## REMARKS

### *Drawings*

FIGURE 1

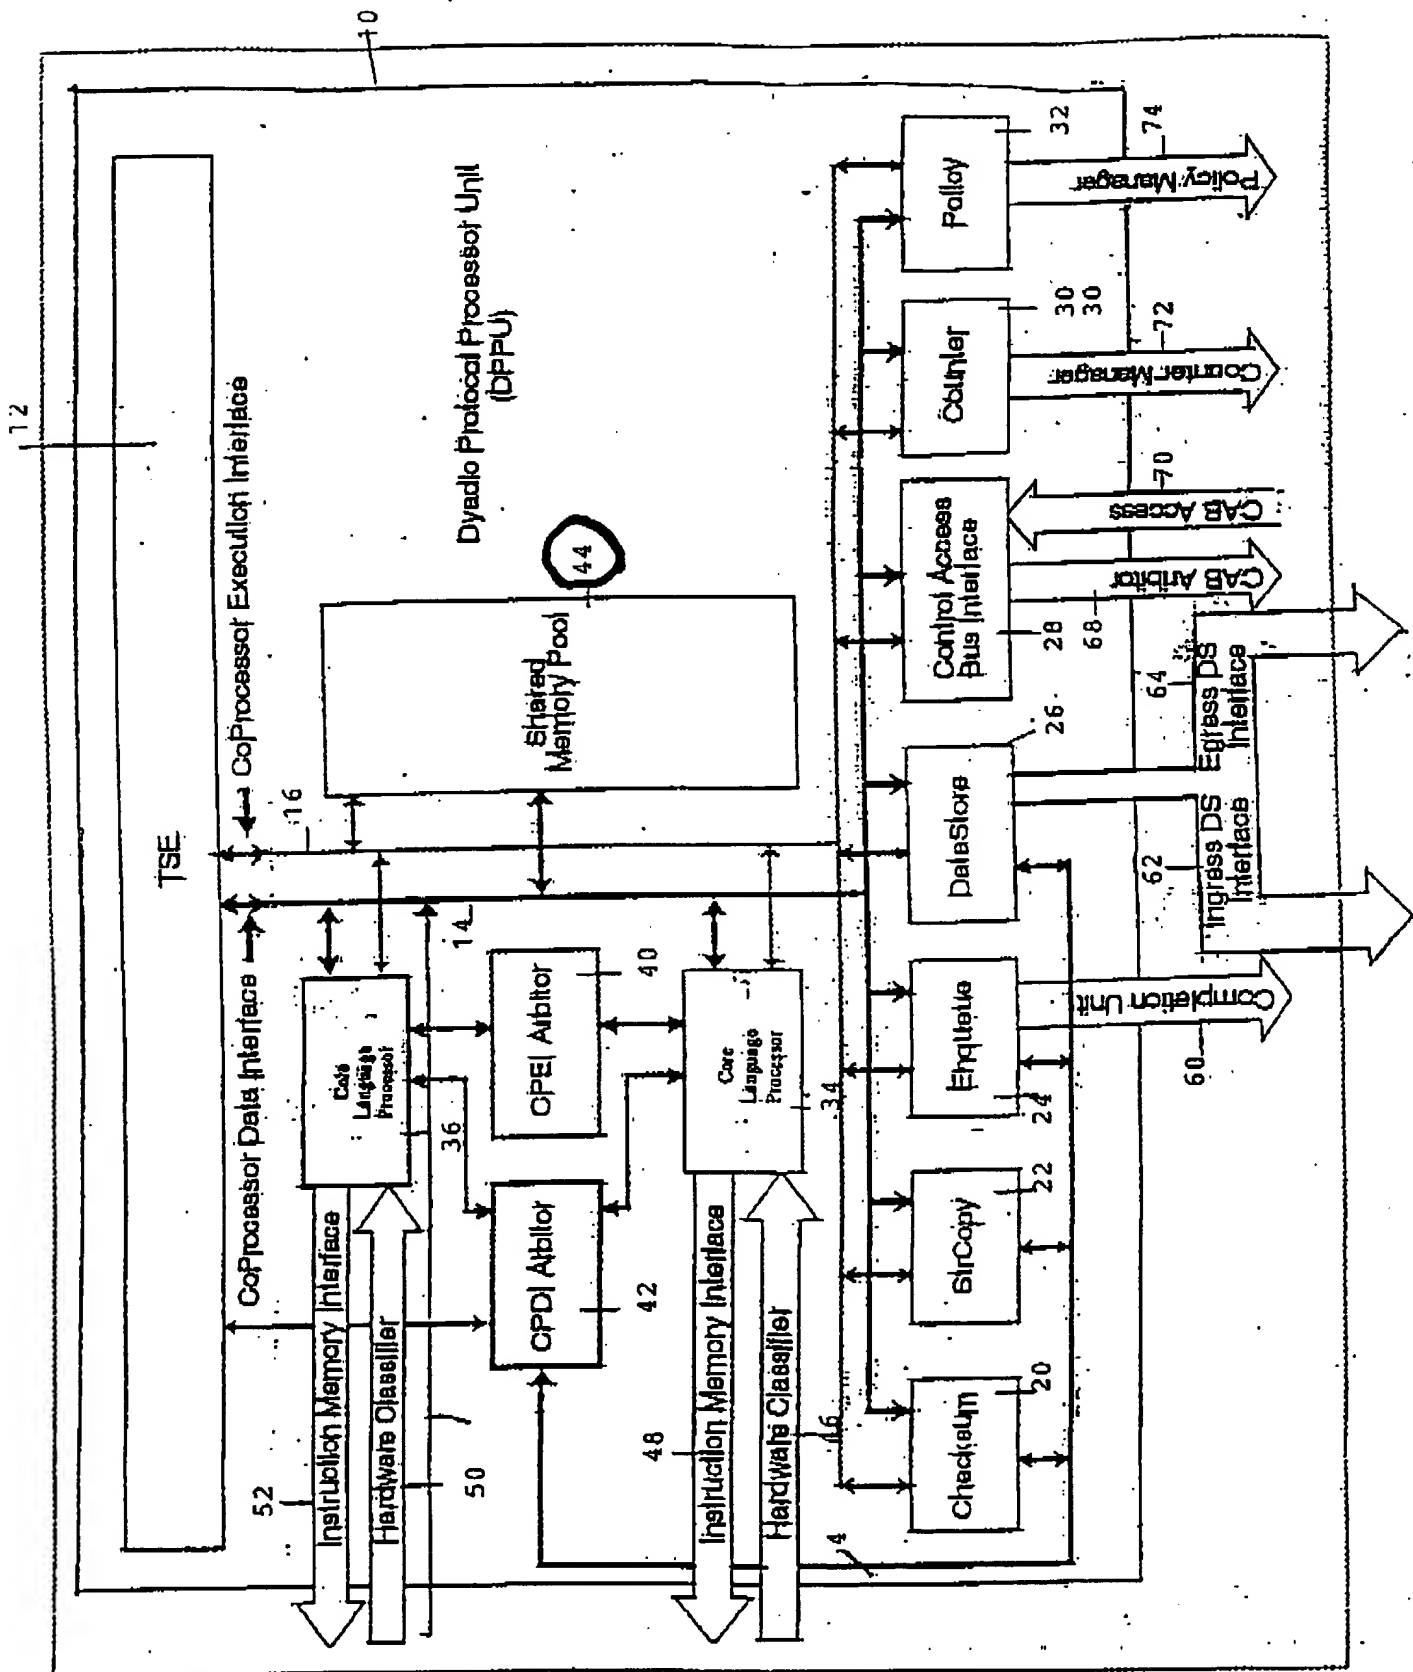
The drawings are objected to as failing to comply with 37 CFR 1.84(p)(5) because they do not include the following reference sign(s) mentioned in the description: 44 of fig 1, 80, 82, 84, 86, 88, 90, 92, 96, 98, 100, 102 of fig 3, 450 of fig. 4, 509, 510, 511, 521, of fig. 5. A proposed drawing correction or corrected drawings are required in reply to the Office action to avoid abandonment of the application. The objection to the drawings will not be held in abeyance.

Applicants respectfully respond to the objections to the drawings by calling the examiner's attention to the fact that most, if not all, of the numbers noted by the examiner are, in fact, included in the drawings. Thus, the numerals 44, 80, 82, 84, 86, 88, 90, 92, 96, 98, 100, 102, 509, 510, 511, 521 all appear in the drawings. Applicants herewith submit Sheets 1, 3 and 5 with the numbers circled for clarification. If there is a discrepancy between the figures herein submitted and the drawing sheets as filed, applicants respectfully request that the examiner advise the undersigned. Furthermore, page 19 has been amended to delete all references to the numeral 450 appearing thereon. The correct part number is 411, which is shown in Figure 4. Applicants respectfully submit that this action is dispositive of the drawing issue.
